CITY OF ALBUQUERQUE

RE: Estates at Glendale Unit 3 (File: B19D027)
Drainage Report, Engineer's Stamp Date 8-12-16
Grading and Drainage Plan, Engineer's Stamp Date 9-22-16

DRAINAGE REPORT

THE ESTATES AT GLENDALE UNIT 3
Albuquerque, New Mexico

SECTION C-C
NTS

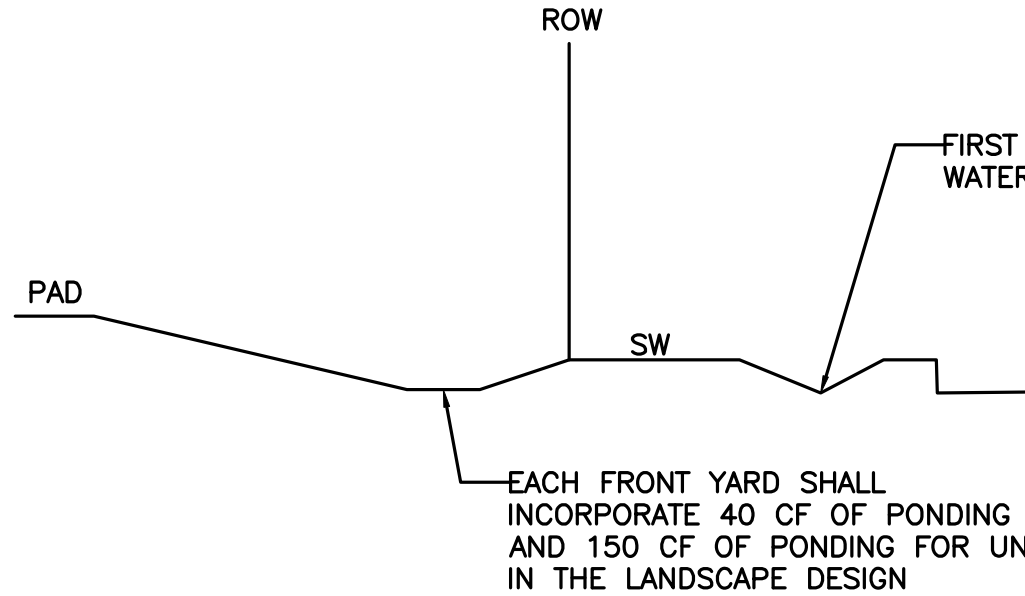
- Revise elevations shown on Section C-C **we have revised**

ESTATES AT GLENDALE UNIT 2 AND UNIT 3		DRAWN BY WCVJ
	GRADING AND DRAINAGE PLAN		DATE 8-16-16
			21425-LAYOUT-12-18-14
	1606 CENTRAL AVENUE SE SUITE 201 ALBUQUERQUE, NM 87106 (505) 872-0999		SHEET # 4 JOB # 21425

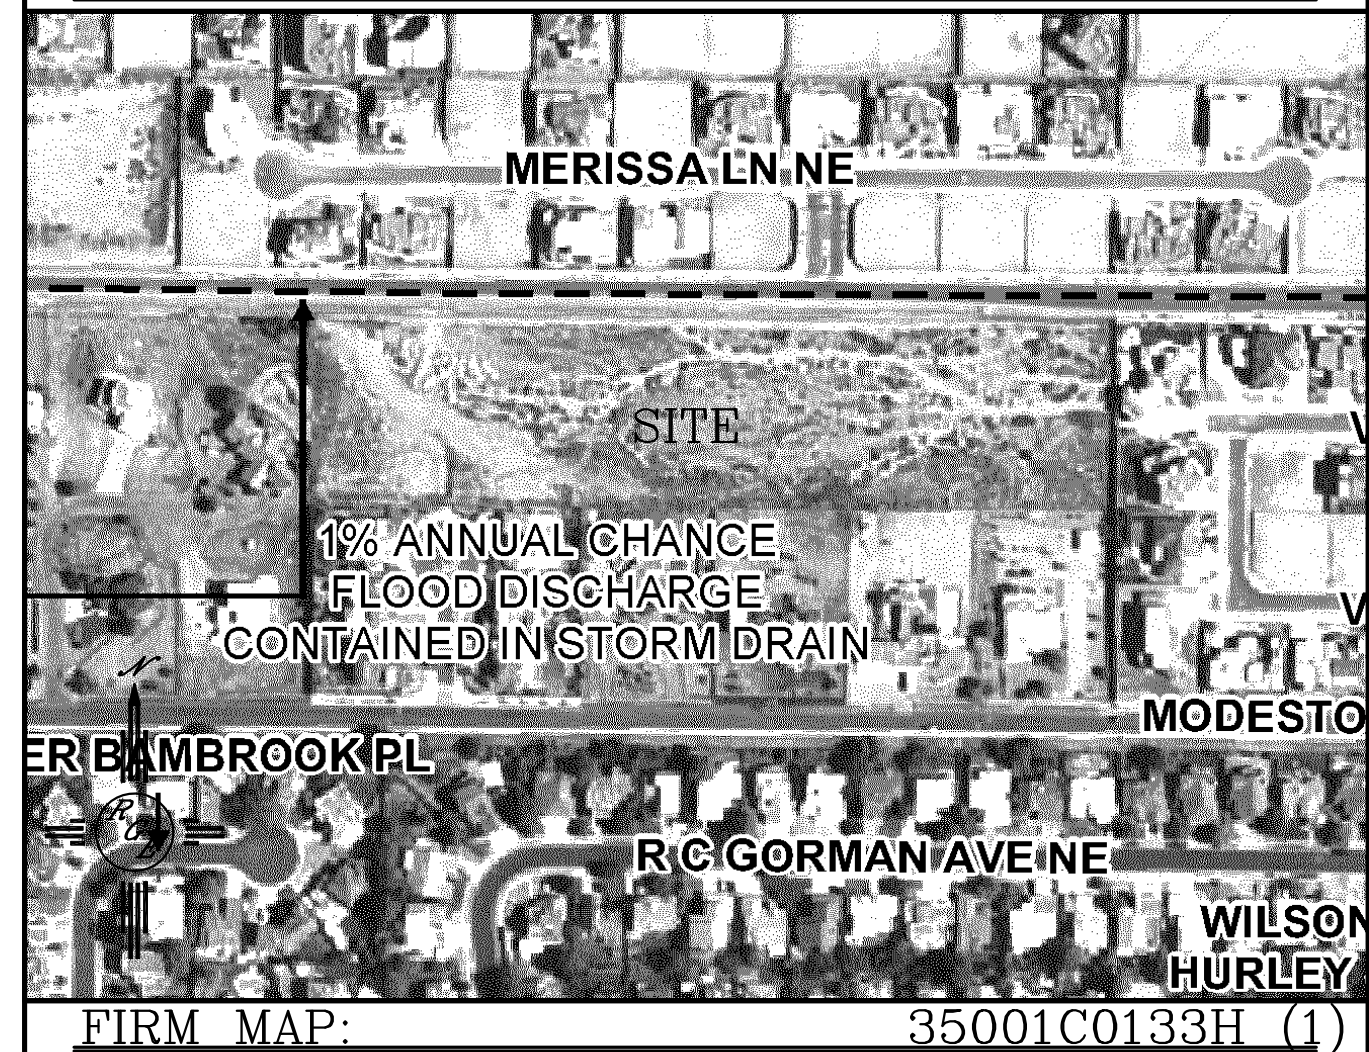
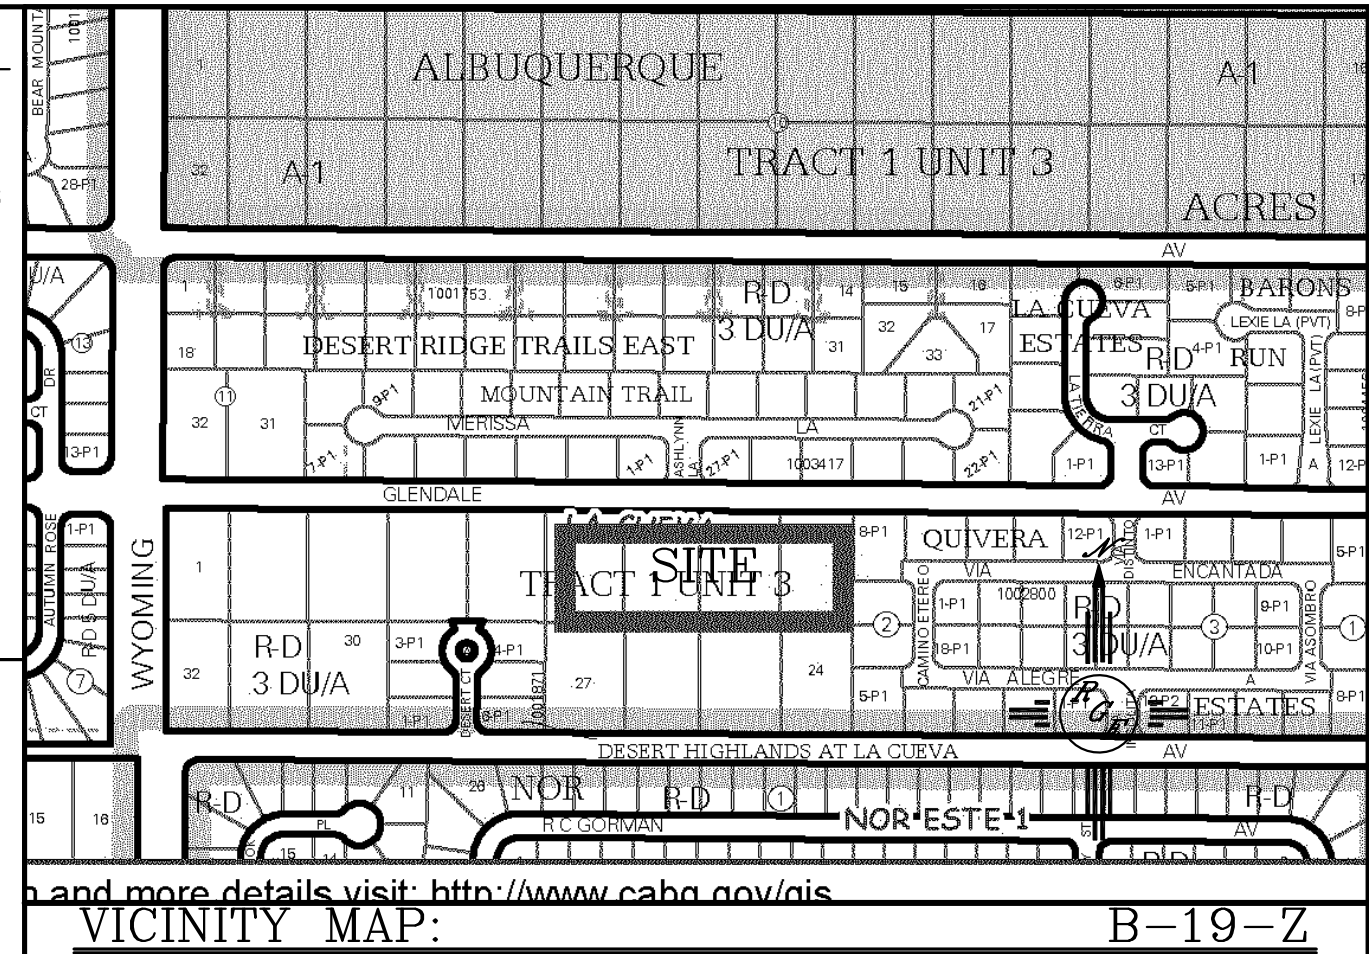
- 6" mountable curb is shown in front of lots 18 and 23, and per our discussion should be standard curb in front of lot 18. 4" curb may be acceptable on the east side of the road, but provide calculations or rational at DRC to justify the lower curb height.

- It is not clear the limits of the Standard Curb and Gutter, and the 4" mountable curb noted in the general notes. Show limits on the Work Order Construction Set.

- Lot 17 has a double wall on the Northern Boundary. The more northern wall is a retaining wall and has ToW and Grade elevations shown. However, the more southern wall is a retaining on the western half. Show where the retaining wall stops and becomes a garden wall. Show ToW and BoW elevations on the as-built.

- For DRB action, the following easements need to be shown on the plat:
 - Lots 17, 18, and 19 will require a Cross-Lot Drainage Easement on the plat for the benefit of Lots 18,19, and 20. Also, ensure the drainage channel is on the I.L.

- Lot 20 will need a Cross-Lot Drainage Easement for the Benefit of Lot 25.
 - A Private Drainage Easement is needed over the SW Culvert to the wall, for the Benefit of Lot 24 and 25. Ensure Drainage channel and SW culvert at end of cul-de sac is on the infrastructure list

- Other items to be on the I.L. are the SW culvert on Glendale and the sump Double C inlet

- Retaining Wall along Eastern Edge: Provide a cross section through this edge. EX. GR Elevation is shown, but needs to be defined on a section. Show the existing wall, with existing TOW and BOW elevations. Is the wall that is shown on the plan a new wall? What is the TOW elevations? **We have added cross section here and added tow and bow grades to the plan. The wall is very tall with screen wall on top . the lots are within a gated subdivision and access is not available.**

- Double Retaining wall on north side of Lot 17: Won't a single wall suffice? **we want the rear yard planter to be consistently 4' therefore we request the double wall remain**

- Add to concrete channel note between Lots 19 and 20 - state to provide clear opening in wall (typical). Begin concrete channel in Lot 20 (need only be extended a foot or two into lot 20) **we have added note and extended wall**

- 6" Mountable curb called out , but General Notes call out 8" Standard Curb Unless Noted Otherwise. Is all the curb to be 6" Mountable? If so the Gen. Note should be removed. **we have revised lableing, we want mountable but standard near the inlets**

- Label Lots 24 and 25 on South side. Add verbiage to the "Turn 2 Blks @ 5427.85" note stating that the opening is to be on the west side of the boundary between Lots 24 and 25. This is to ensure that they do not put the opening on the wrong side. **we have added so flow is allowed to pass thru each lot**
- Slide the SW Culvert and concrete Channel to the east to align with the above mentioned turned blocks. **we have shifted and widened to accept from both lots**
- SW Culvert note says 2 -2' culverts but channel is only 2' wide. Since only 2.68 cfs, won't a narrower channel and SW culvert suffice. **we have revised to have only 1 -2' culvert**

- Lots 17, 18, and 19 will require a Cross-Lot Drainage Easement on the plat. Provide the Plat showing all easements. **This is coming to drb in the coming weeks, we will have on plat. we have added into the notes section**
- Lot 20 will need a Cross-Lot Drainage Easement for the Benefit of Lot 25. **This is comming to drb in the comming weeks, we will have on plat. we have labeled**
- A Private Drainage Easement is needed over the SW Culvert to the wall, for the Benefit of Lot 24. **This is comming to drb in the comming weeks, we will have on plat. we have labeled**

SECTION A-A

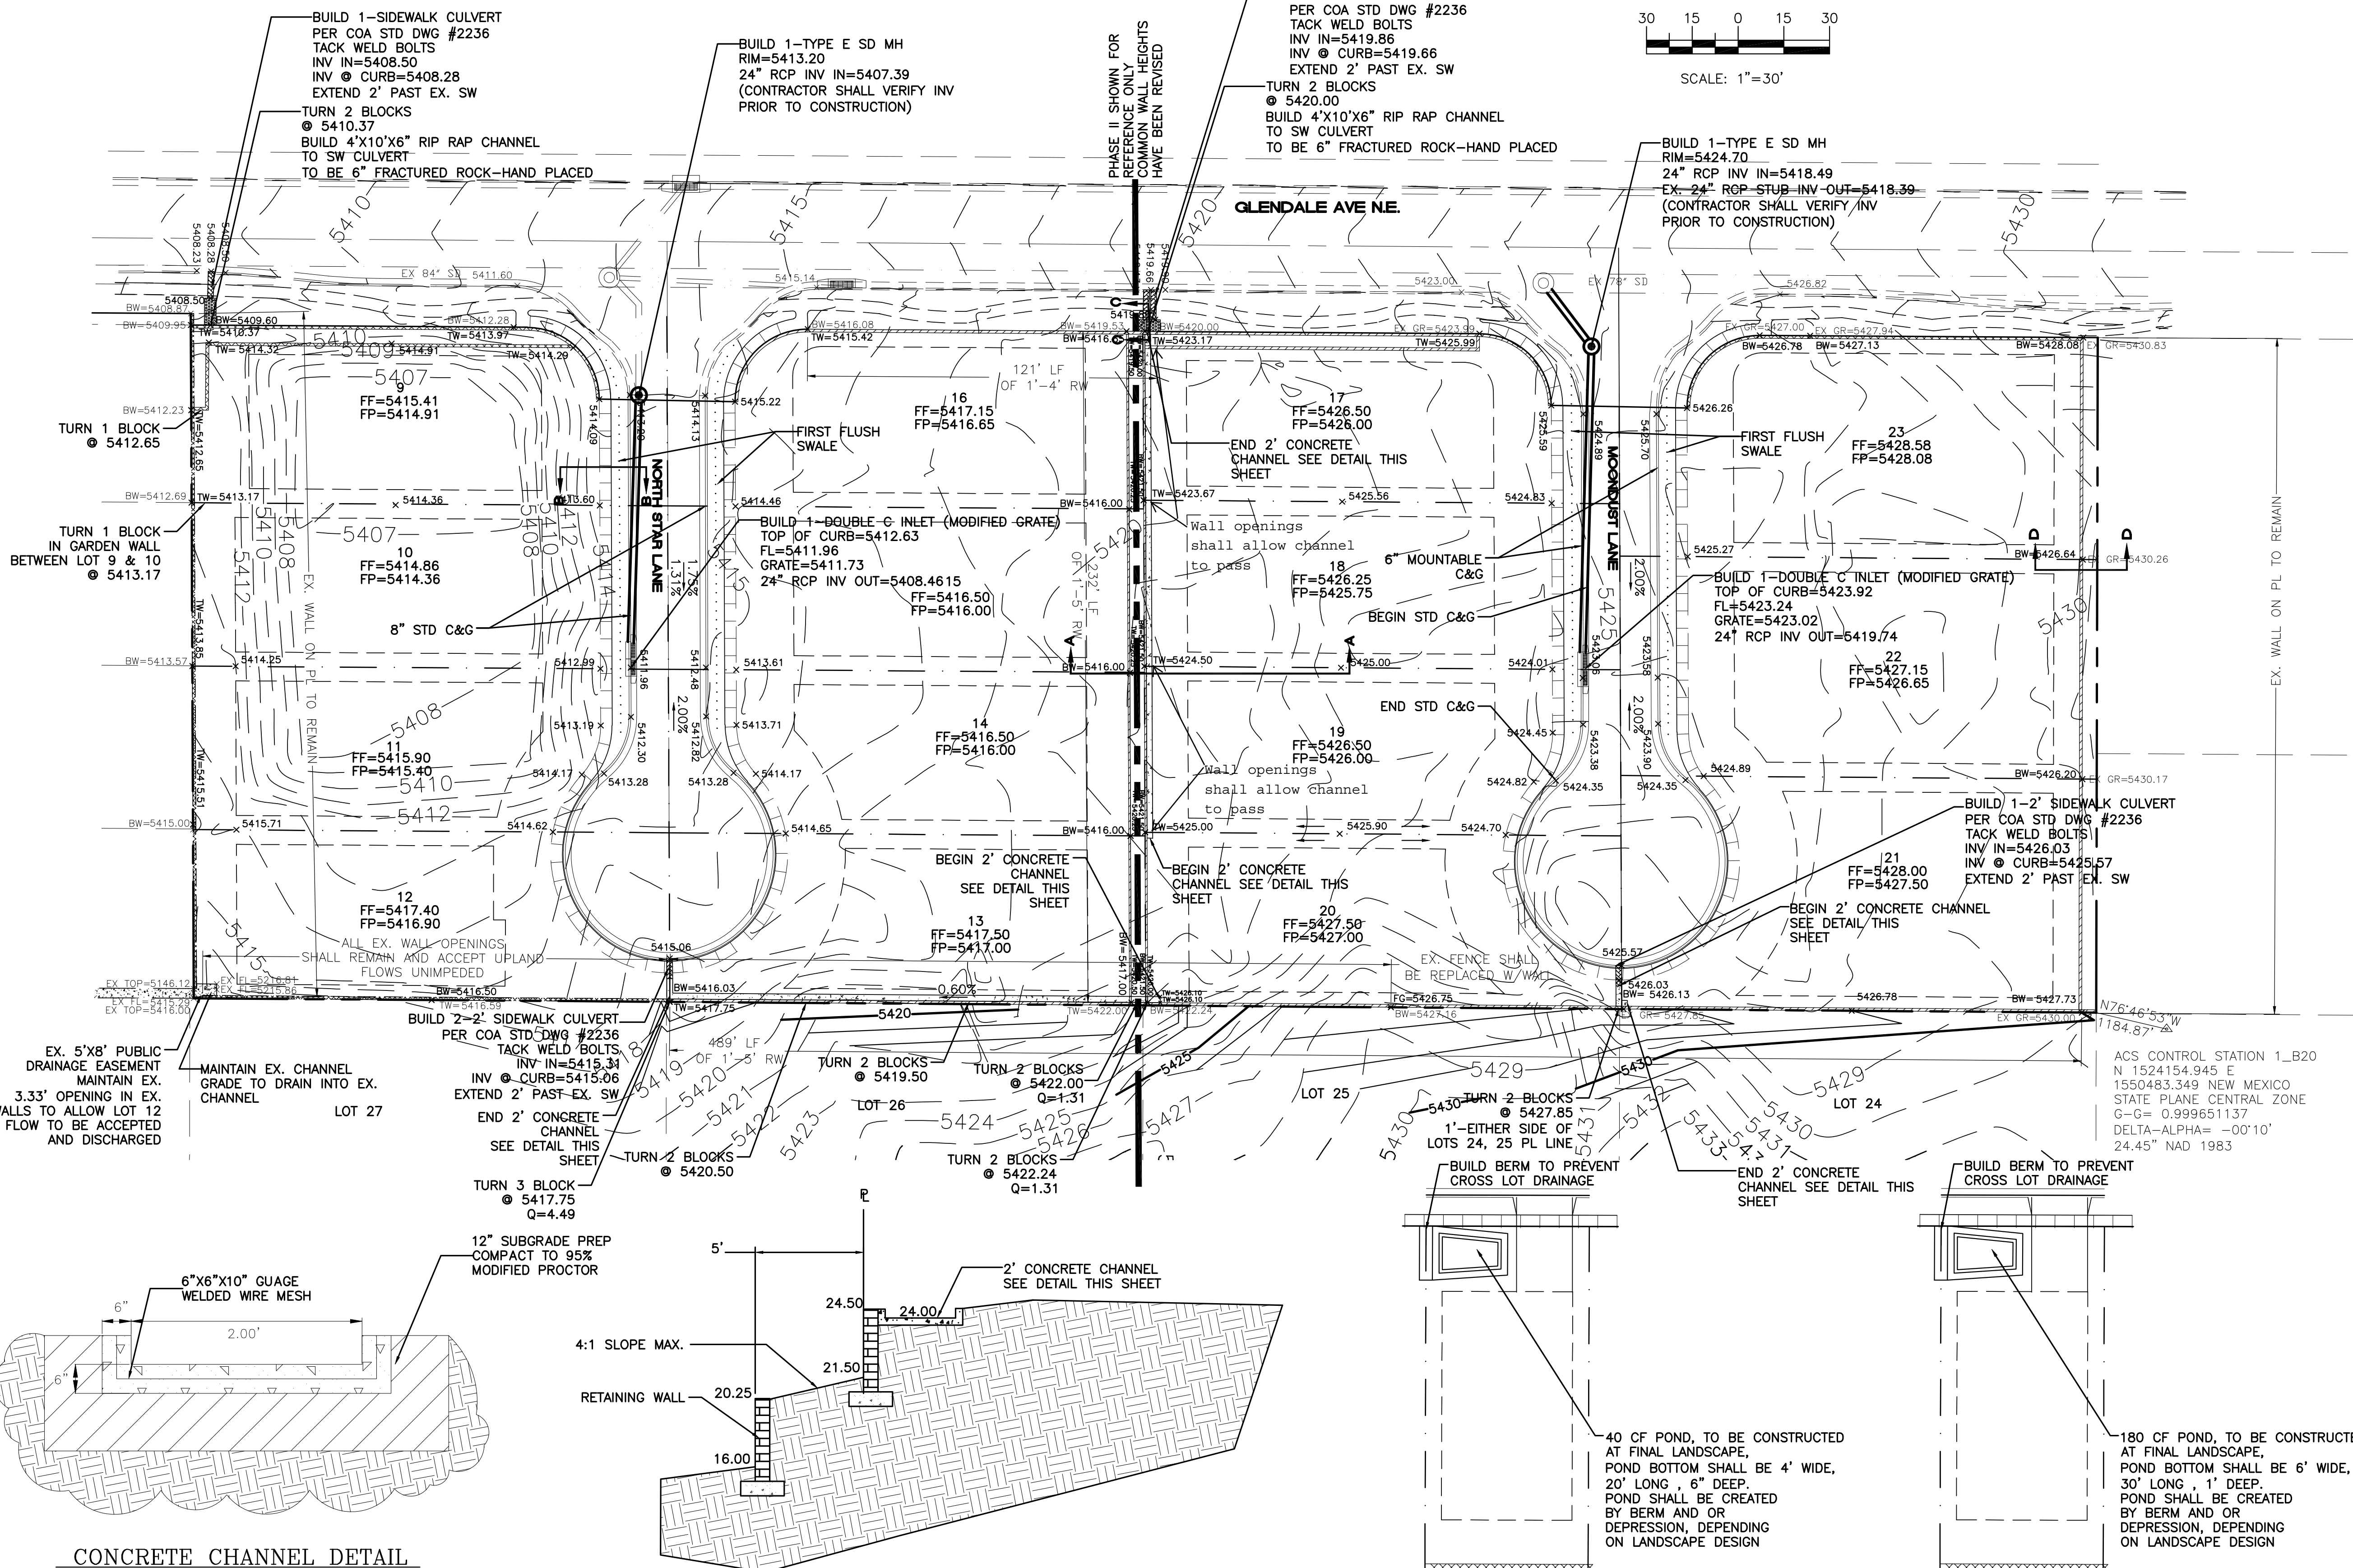
- Double Retaining Wall Between Unit 2 and Unit 3 Shown in Section A-A: The finished grade of the lower retaining wall was raised to limit the wall heights. However, the raised FG Elev. is now at FF Elev for lots 14 and 15. I realize the intention is to slope the grade from the wall to the rear of the house to an elevation lower than FF, but it is highly unlikely that homeowners will leave a low point there at the rear. They will likely level out the back yard for landscaping or slope back towards the wall. Therefore, the FG Elev at the bottom of the lower should not be changed from the approved plan for Unit 2. **We have revised the grades so the bottom of wall is a the same elevation as the pad.**

- Shouldn't the SW Culverts along Glendale be aligned with the concrete channel? **We have shifted the culverts**
- Section A-A cut in wrong direction. Put Channel on Infrastructure List **we have corrected and the channel will be on the list**
